**FINAL**

**Interim Measures Work Plan  
Expanded Bioventing System  
SWMU 55 (IRP Site FT-03)**

**Charleston Air Force Base  
South Carolina**

**April 1997**

As-Built Schematic of Pilot Test Vent Well

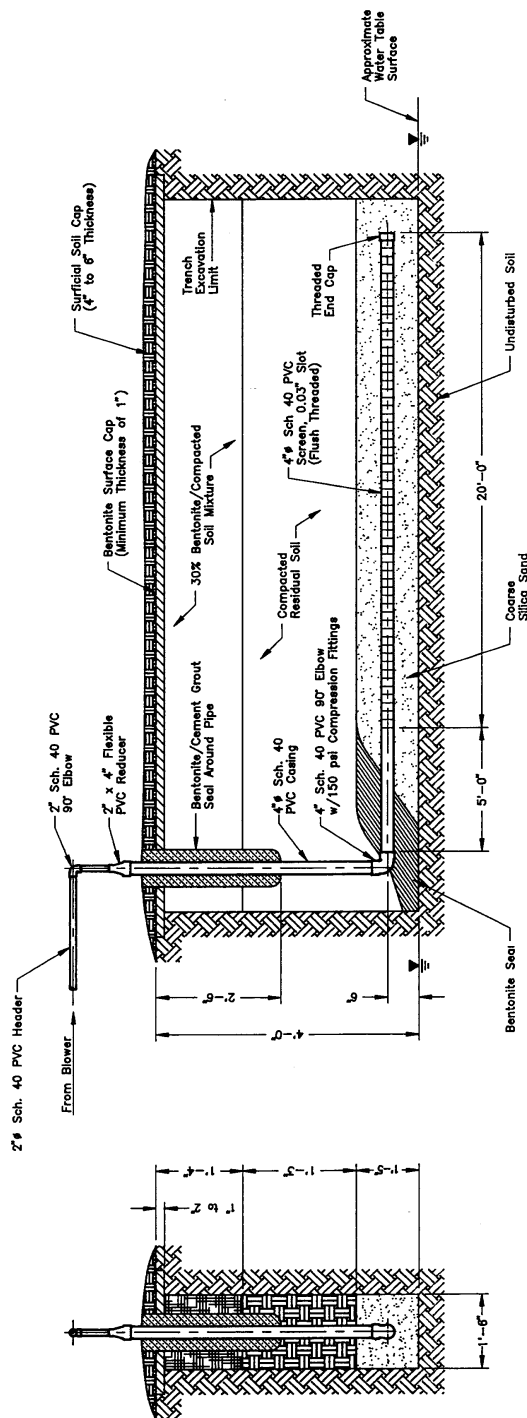
*iii) Will the new underground air supply be grouted in place? Figure 3.2 shows the vertical casing exiting the ground surface through a grouted annulus, while Drawing G-0.3 describes a grouted annulus without showing it graphically.*

- iii) Figure 3.2 shows an as-built diagram of the existing pilot test vent well. The existing vent well will be retrofitted for below grade completion by removing part of the existing grout seal and attaching a new 2" air injection header pipe. This header pipe will not be grouted in place. Drawing G-0.3 shows the proposed new horizontal vent well. The 4" vertical riser pipe on this well will have a minimum 1-foot bentonite/grout seal. This seal is identified with text on Drawing G-0.3, but the symbol is missing graphically. This seal will be installed and the symbol will be corrected on the as-built drawings.
